# ***Environmental Impact Statement***

## **ADDENDA NO. 01**

### ***N4 Collooney to Castlebaldwin Proposed Road Development***

Figure No.:  
Fig.: 4.10

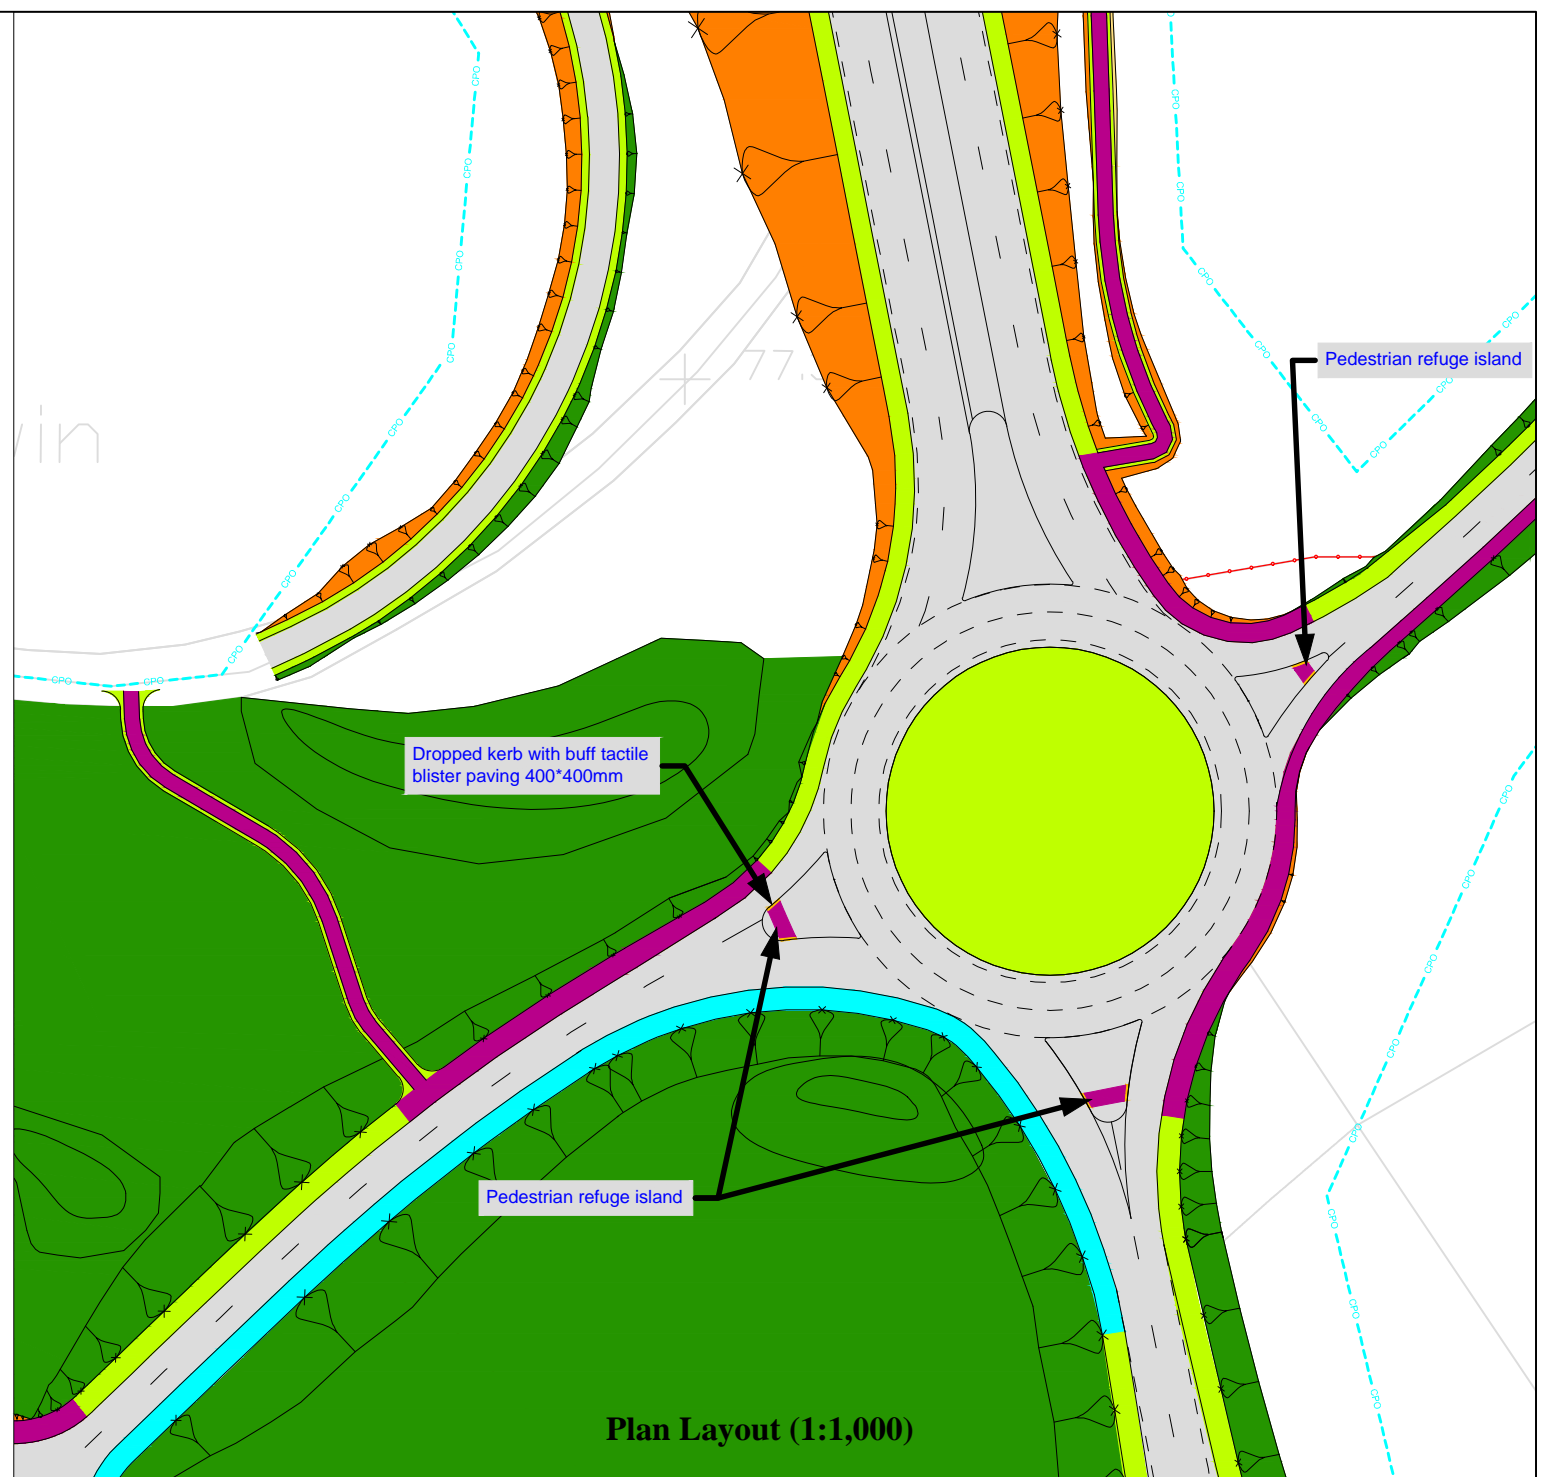
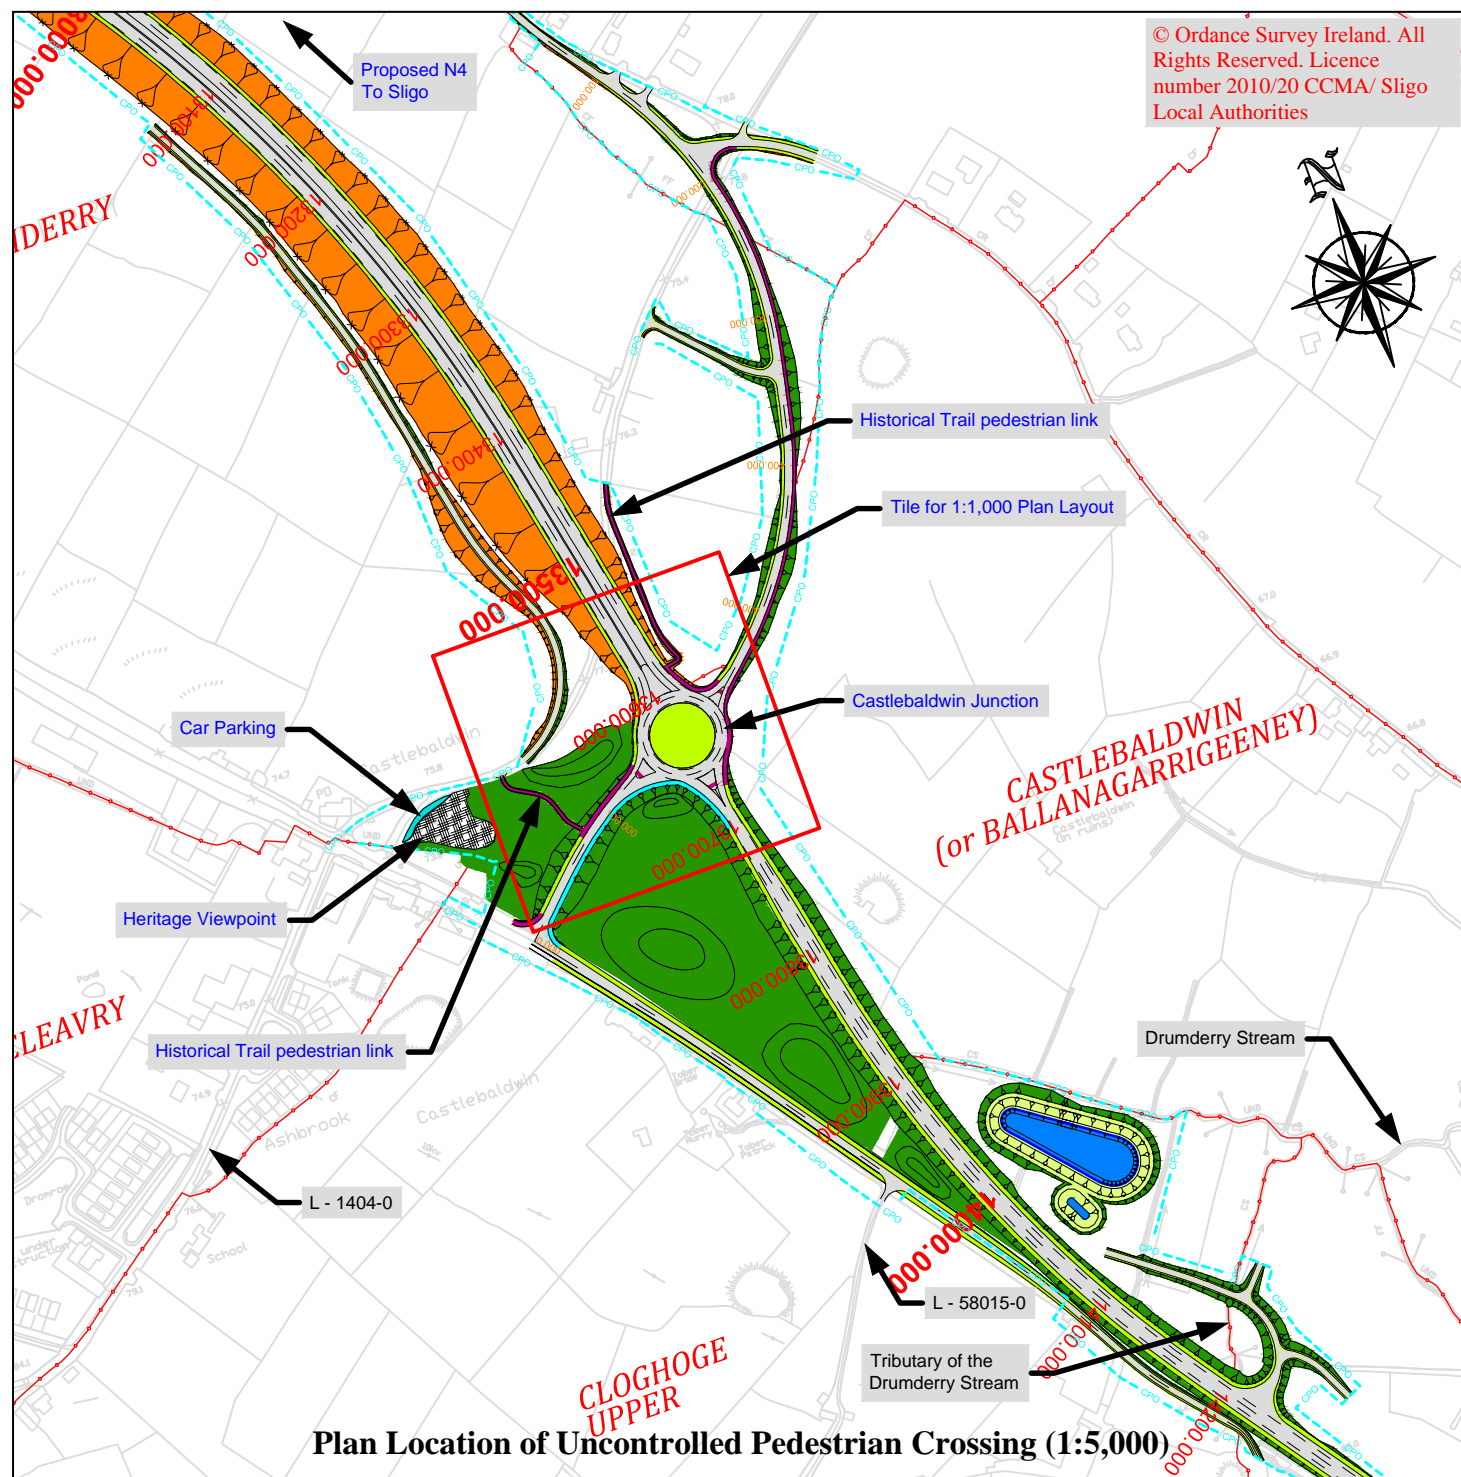
#### **Figure 4.1.8 and 4.10**

The pedestrian trail is re-linked to provide the uncontrolled crossing on the Standard Single Carriageway section (at a refuge island) of the proposed N4 as opposed to the Type 2 Dual Carriageway. This will shorten the time to travel across live carriageways on the national network.

| Date       | By | Revision  |
|------------|----|---|
| April 2014 | FM | This is an addenda to the EIS as described in Addenda Sheet No. 01.   |
|            |    | The historical trail pedestrian link has been re-linked to provide the uncontrolled crossing on the Standard Single Carriageway section of the proposed N4. |

|  |                          | Figure No.:<br>Fig.: 4.9.3 |

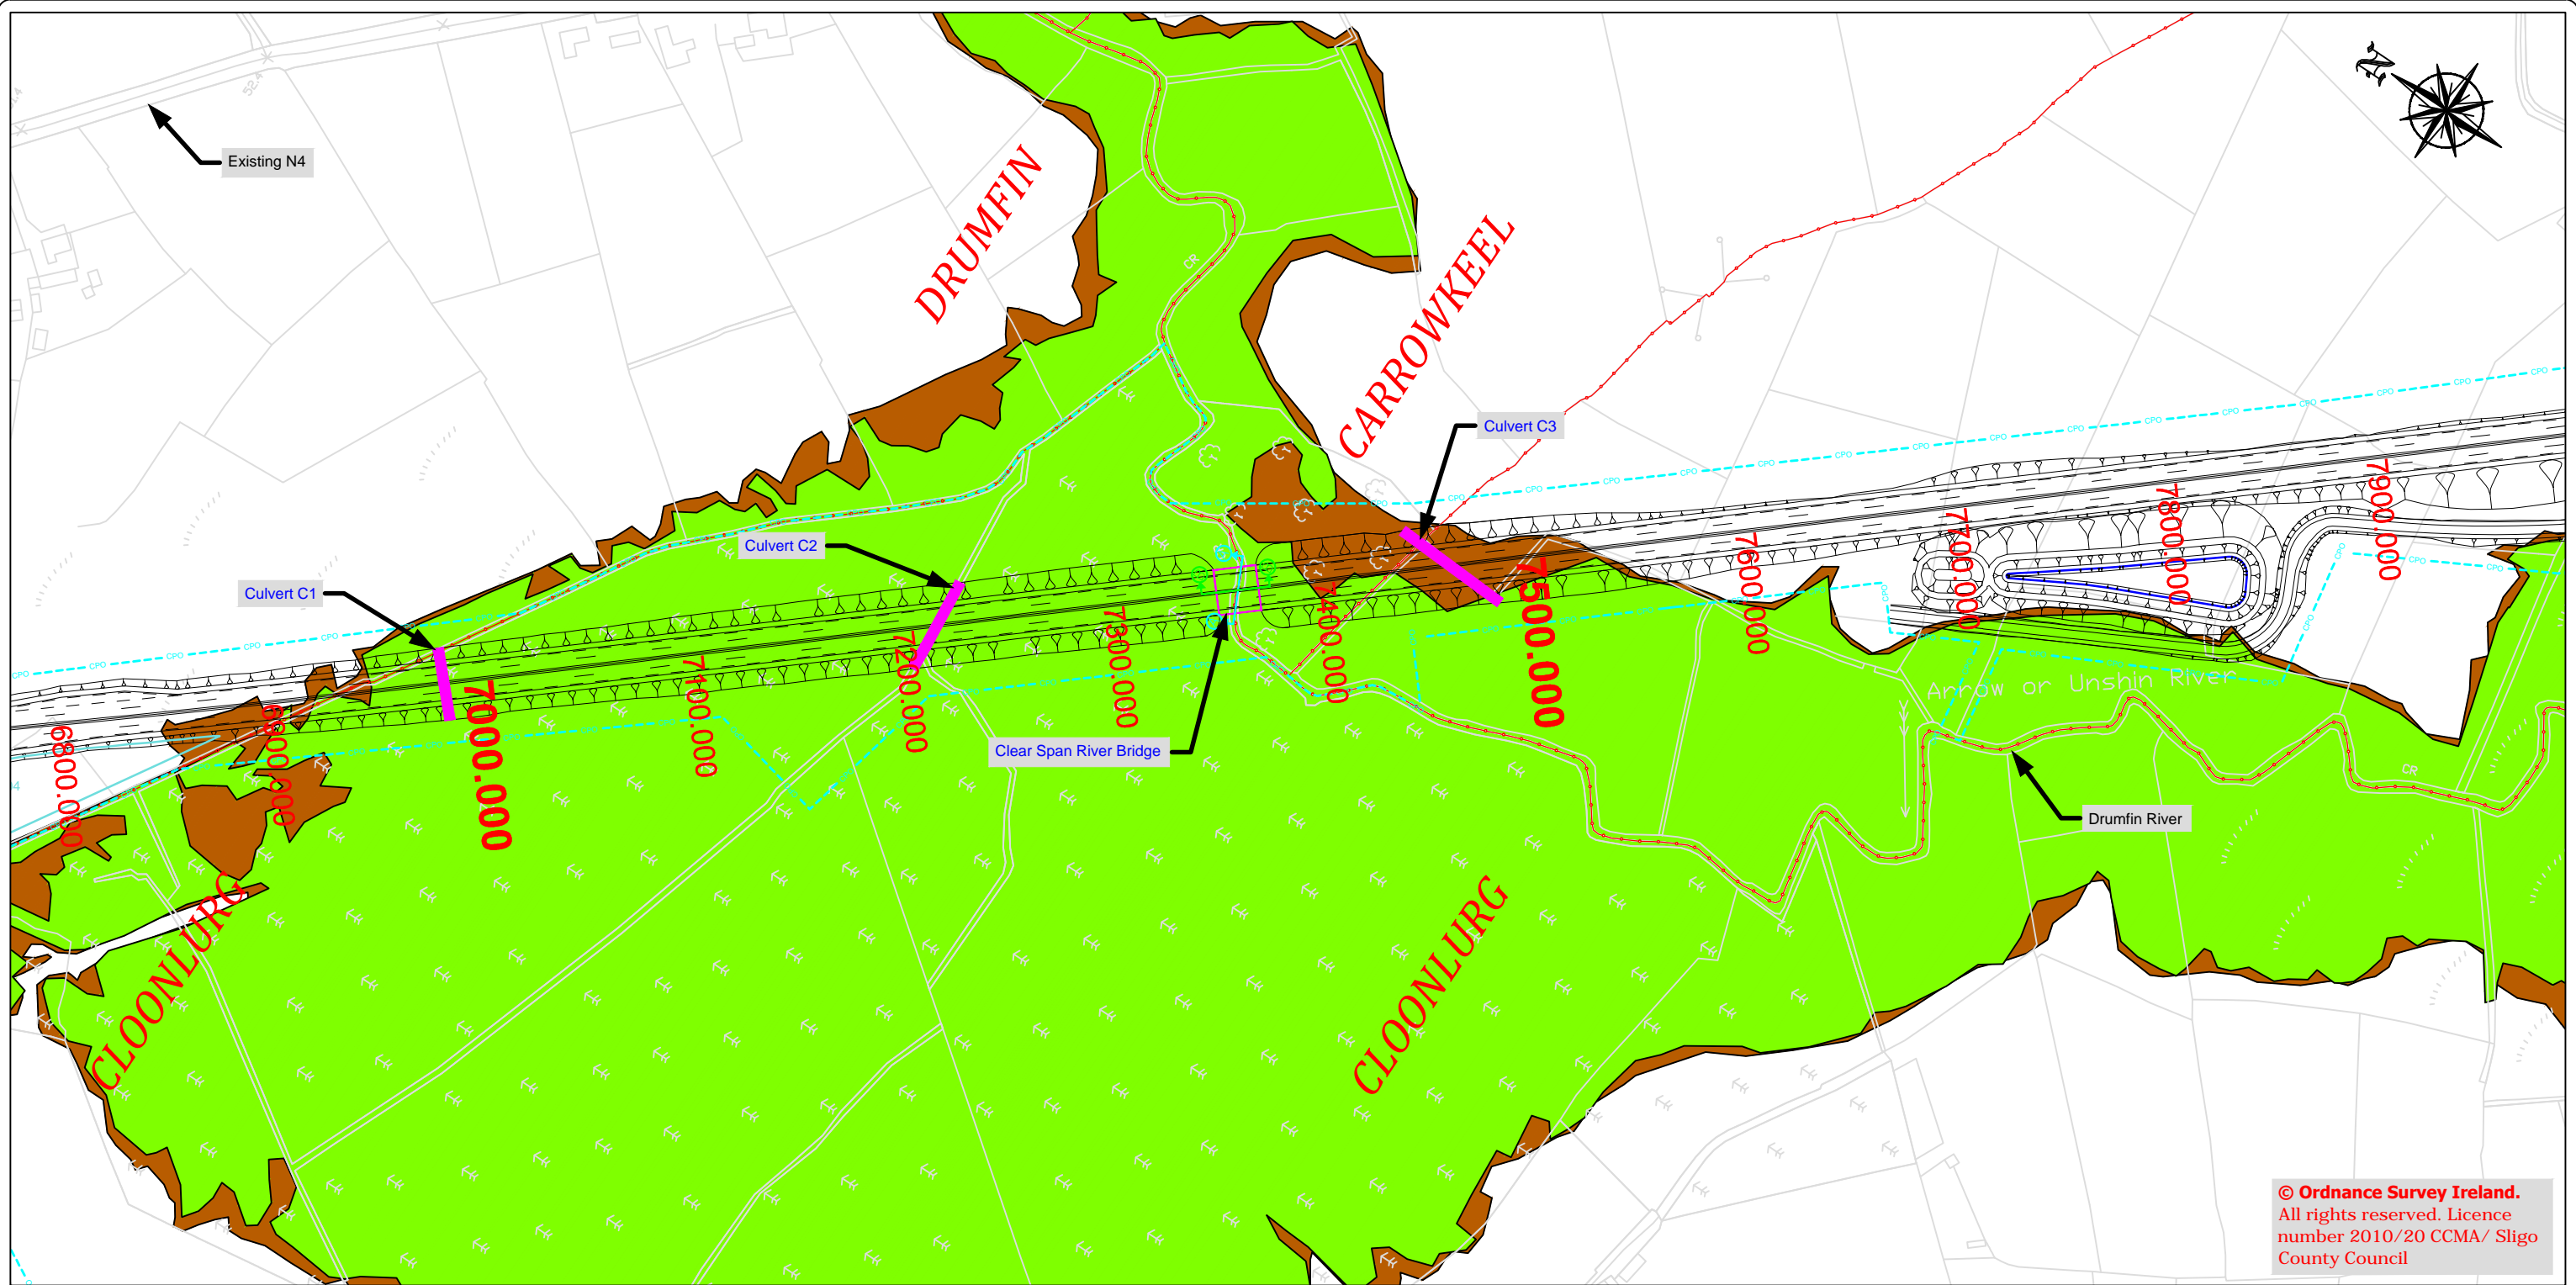
#### **Figure 4.9.3**

This map relocates culverts in the flood plain to further improve flood plain connectivity.

| Date       | By | Revision  |
|------------|----|---|
| April 2014 | FM | This is an addenda to the EIS as described in Addenda Sheet No. 01.                       |
|            |    | Culverts have been relocated in the flood plain area to improve flood plain connectivity. |

|  |                                 | <b>Figure No.:</b><br>Fig.: 10.1.8<br>Sheet 8 of 8 |

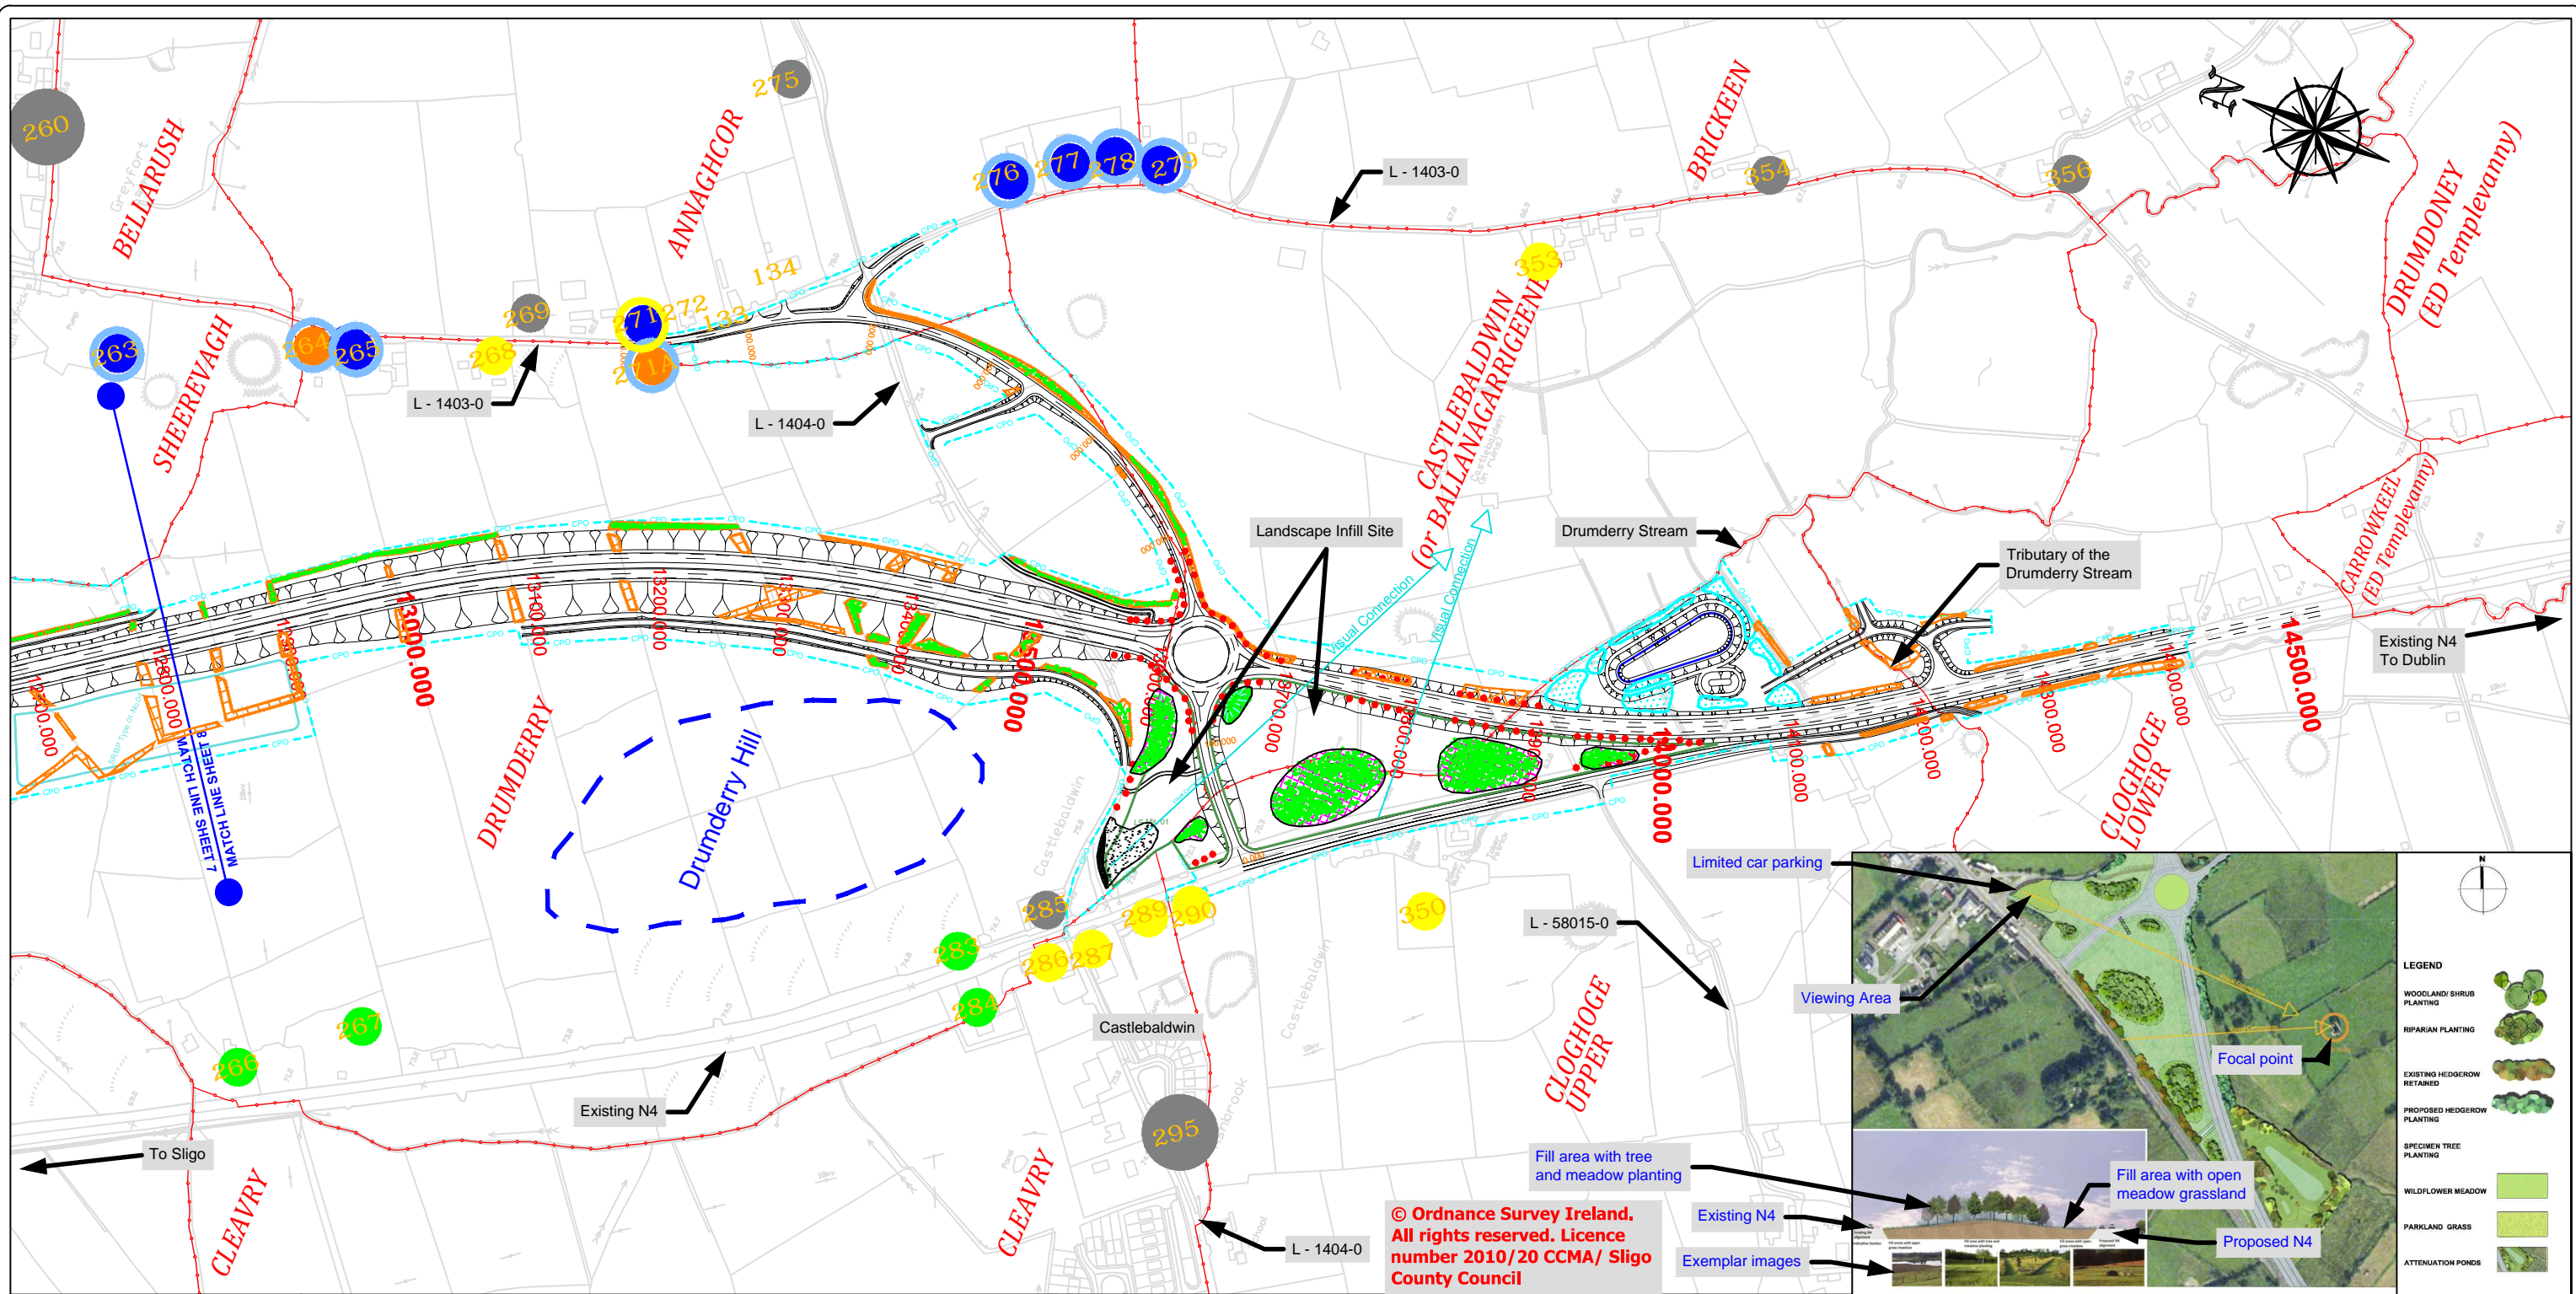
#### **Figure 10.1.8**

For clarity, more information is added in relation to the landscape infill site.

| Date       | By    | Revision  |
|------------|-------|---|
| April 2014 | FM/CW | This is an addenda to the EIS as described in Addenda Sheet No. 01.<br>The landscape image in the lower right corner is enhanced for clarity. |
